**WANGER JONES HELSLEY PC**  
ATTORNEYS

**Re: Appeal of Planning Commission Approval of Red Hills  
BioEnergy Project Major Use Permit UP 19-05, Initial  
Study/Negative Declaration IS 19-09**

Dale La Forest & Associates  
Environmental Design & Planning  
101 E. Alma Street, Suite 100-A  
Mt. Shasta, California 96067  
dlaforest@gmail.com  
Phone: (530) 918-8625

**Figure B – Illustration of Generators' Proximity to Nearest Off-site Homes**

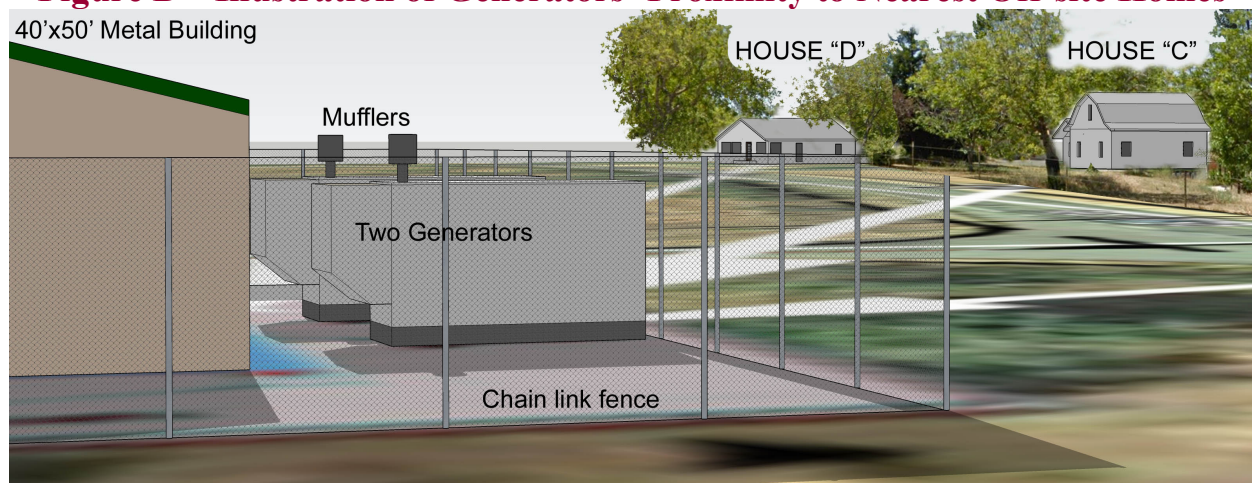
One of this Project's most significant noise impacts will occur from the 24-hour per day operation of the two diesel-powered electrical generators as heard at some nearby homes. The IS/MND fails to accurately disclose that significant noise impact. The IS/MND, p. 4, "Site Plan," shows the two "Level-2" aluminum-housed Gen-Sets proposed to be located outside the metal building on its west side and with direct line-of-sight to some off-site residences, as illustrated here:

**Figure D – Generators' Proximity to Nearest Homes**

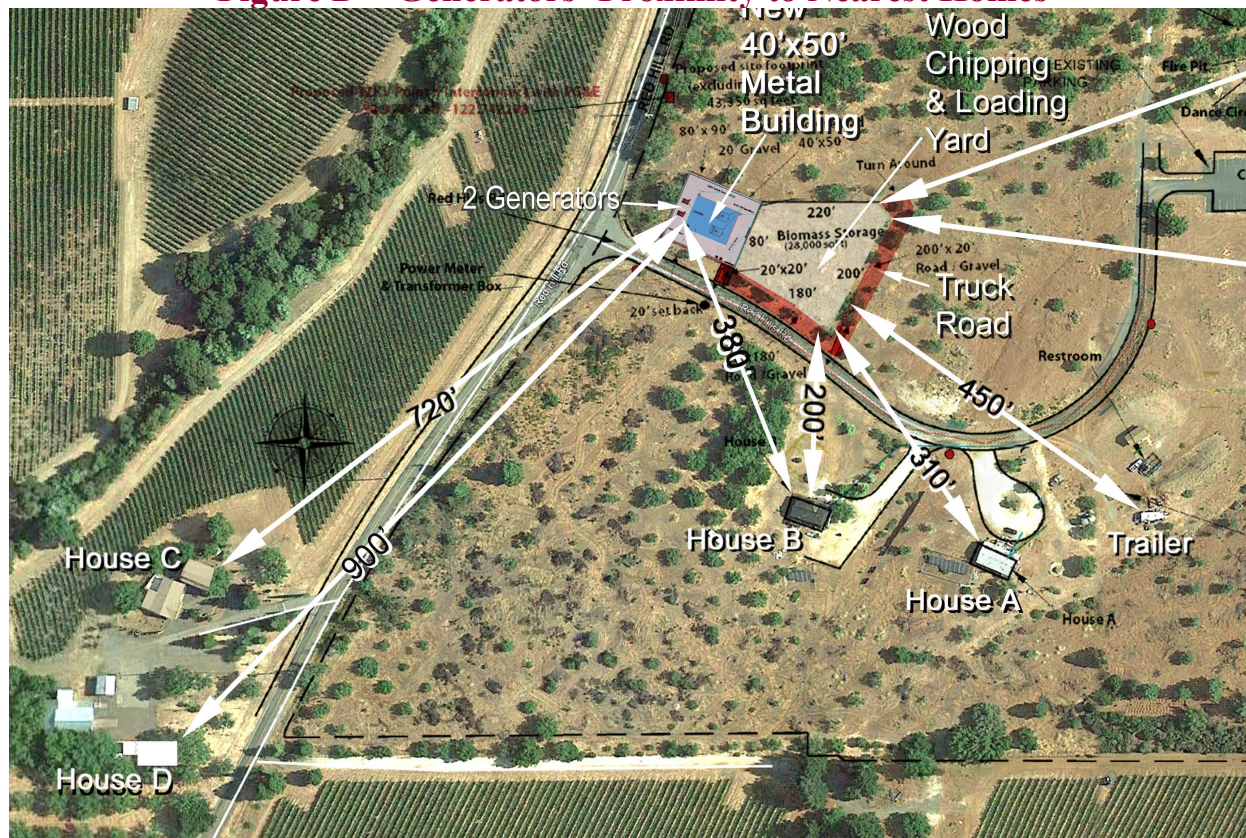
The IS/MND is vague about the locations and distances of the nearby homes from this Project's noise-generating construction activities and operations. Accordingly, assuming a reasonable worst case location as described below, the Project's noise impacts to these sensitive receptors would be potentially significant. For example, the IS/MND describes the proposed Generators being about 800 feet from the nearest off-site residence (House C), but Google Earth's measurement tool shows a distance of about 720 feet there.<sup>21</sup> That difference is significant because generator noise could be about **1 dB louder** at that **House C's** closer distance, and a 1 dB loudness error might make the difference between complying with County standards or not complying. The IS/MND provides no accurate distances from this Project's two generators to other nearby homes that will also be exposed to this excessively-loud generator noise (i.e., Houses A, C, and D).

**Figure G – Generators' Proximity to Nearest House "B"**

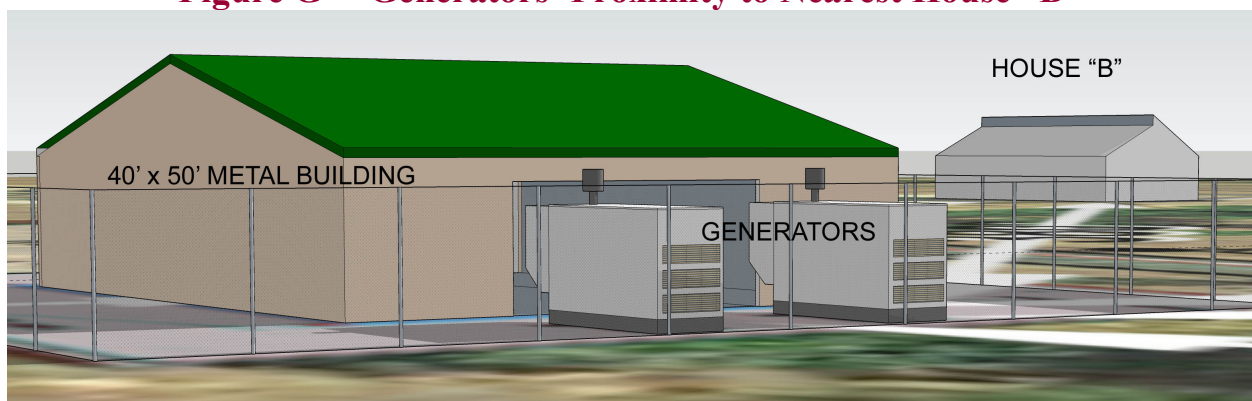
$$dB_2 = dB_1 - 10 \times A \times \text{LOG}(R_2/R_1) = 86.1 - 10 \times 2.0 \times \text{LOG}(380' / 23') = \mathbf{61.7 \text{ dBA}}$$

The 40' x 50' metal building at most will only shield a direct line-of-sight to one of the two generators. Sound waves also bend around objects rather than travel in straight lines, so noise

**Figure A (repeated for convenience) – Map of Noise Sensitive Receptors Near Project Site**

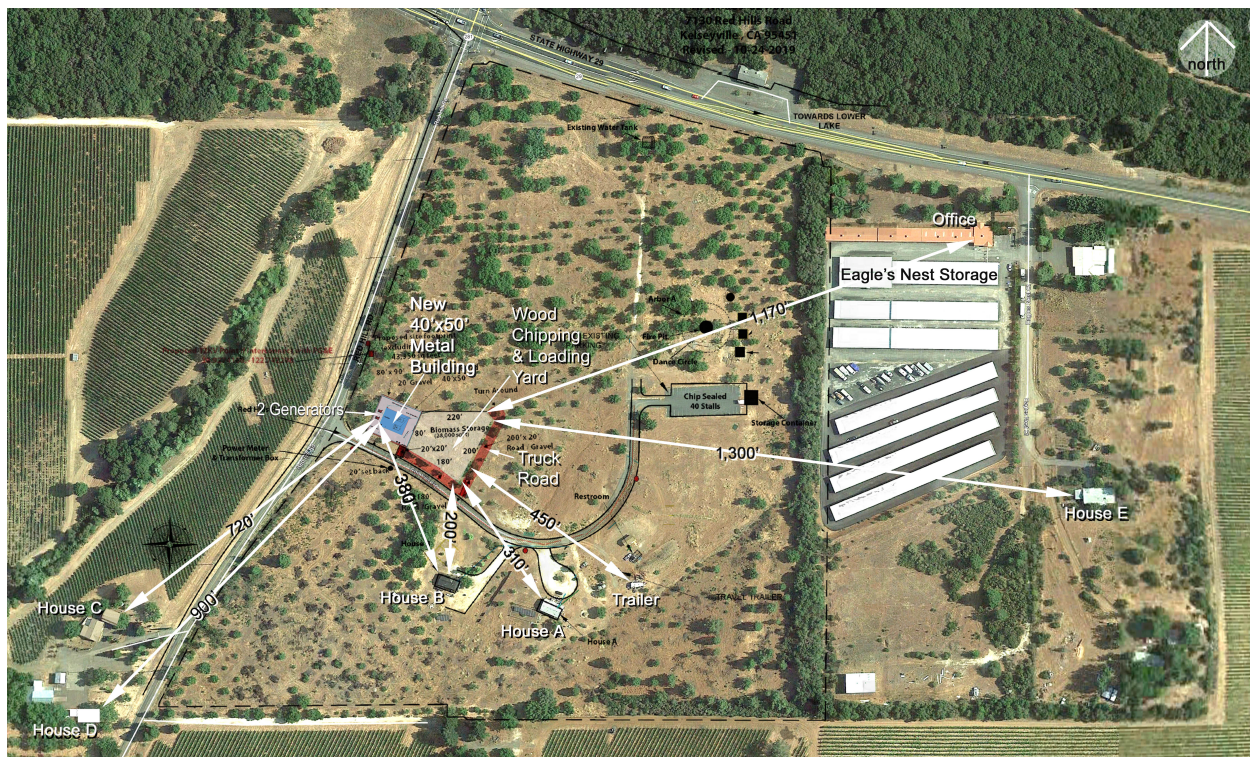
This mitigation makes no sense and thus is unenforceable. The Project site itself is hardly more than about 1,800 feet wide (from east to west) at its southern property line. There appears to be no location on the entire site where the chipper could be placed where it would be *“not less than 1,800 feet from the eastern property boundary.”*

That proposed new mitigation also seems to indicate that a tub grinder may also be located somewhere on this Project site.<sup>29</sup> No location for that tub grinder is shown in the IS/MND so its noise impact cannot be accurately predicted. That may not be necessary though at this time since even the location of the smaller and quieter chipper would exceed the County’s noise standards at the sensitive receptors. If the tub grinder will indeed operate on this Project site, its noise impact can be cumulatively considered in an EIR. If the tub grinder will instead be operated somewhere off-site, then the IS/MND is inadequate because it has not indicated that and the potential noise impacts of that undisclosed off-site location have not been evaluated.
